Access Compliance Report

Public Rights-of-Way

Intersection ID: 10017663	Main Street: STATESVILLE_AV	Cross Street: N/A	Location: E
ADA ID: AD621BF80E8A	Ramp Type: BlendTrans1	Initial Pass/Fail: Fail	Overall Compliance: No
		Severity Score: 10

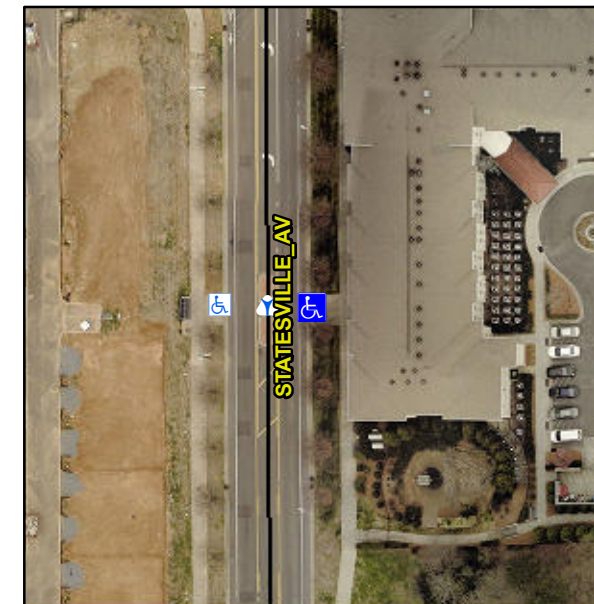
Not Found, R304.5.1, R304.5.3

Compliance	Description	Data	Compliance	Description	Data
N/A	Ramp Length (in)	172.0	Yes	BlendTrans Slope (%)	3.5
No	Ramp Width (in)	47.0	No	BlendTrans XSlope (%)	2.3
N/A	Flare Type LT	N/A	N/A	Flare Type RT	N/A
N/A	Flare Slope LT (%)	N/A	N/A	Flare Slope RT (%)	N/A
N/A	Flare Traversable LT?	N/A	N/A	Flare Traversable RT?	N/A
N/A	Landing Length (in)	N/A	N/A	DWS Provided?	N/A
N/A	Landing Width (in)	N/A	N/A	DWS Contrast?	N/A
N/A	Landing Slope (%)	N/A	N/A	DWS Length (in)	N/A
N/A	Landing X Slope (%)	N/A	N/A	DWS Full Width?	N/A
N/A	Landing Curb? (Y/N)	N/A	N/A	DWS Offset (in)	N/A
N/A	Shared Landing?	N/A			
N/A	Gutter Ponding?	N/A	N/A	Gutter Slope (%)	N/A
N/A	Gutter Lip Ht (in)	N/A	N/A	Gutter X Slope (%)	N/A
N/A	Painted X Walk1?	No	N/A	Painted X Walk2?	N/A
	X Walk 1 Direction	To W		X Walk 2 Direction	N/A
	X Walk 1 Width (in)	N/A		X Walk 2 Width (in)	N/A
	X Walk 1 Slope (%)	3.7		X Walk 2 Slope (%)	N/A
	X Walk 1 X Slope (%)	2.1		X Walk 2 X Slope (%)	N/A

N/A	Ramp inside XWalk1?	N/A	N/A	Ramp inside XWalk2?	N/A
	Road Slope (%)	2.1		Clear Space?	N/A
	Road X Slope (%)	3.7	N/A	Clear Space to XWalk (in)	N/A
N/A	Any Obstructions?	N/A	N/A	Storm Grate/Utility Hazard?	N/A
	Obstruction Type			Storm Grate/Utility Type	
		N/A			N/A
			Yes	Surface Condition? (G/P)	Good
			No	Curb Slope (%)	24.6

Remove & Replace Curb Ramp With Two New Directional Ramps or Equivalent.
